# UNITED STATES PATENT AND TRADEMARK OFFICE

APPLICATION NO.	FILING DATE	FIRST NAMED INVENTOR	ATTORNEY DOCKET NO.	CONFIRMATION NO.
10/719,352	11/21/2003	John R. Wall	3257-031853	3304

**Office Action Summary**

### **DETAILED ACTION**

Figure 1

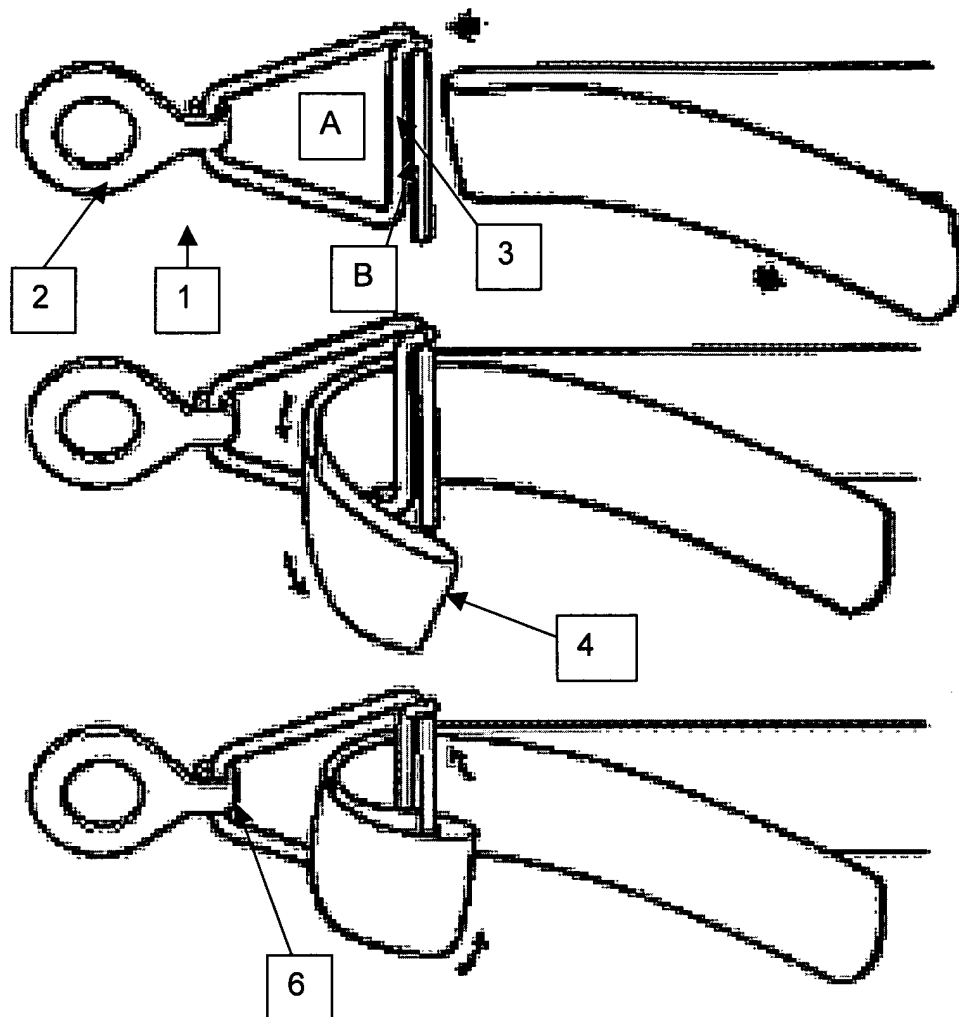
As to claim 3, Safe-Fence in view of Johnson discloses a fence wherein the end connector is attached to the post using a fastener (see figure 1) which permits the connector to pivot about the fastener.

As to claim 6, Safe-Fence in view of Johnson discloses a fence wherein the faceplate (encompasses the entirety of 1 includes a bend between the first slot and the post attachment end (2) (this is shown in figure 1 in the photo of the R-50 corner tensioner).
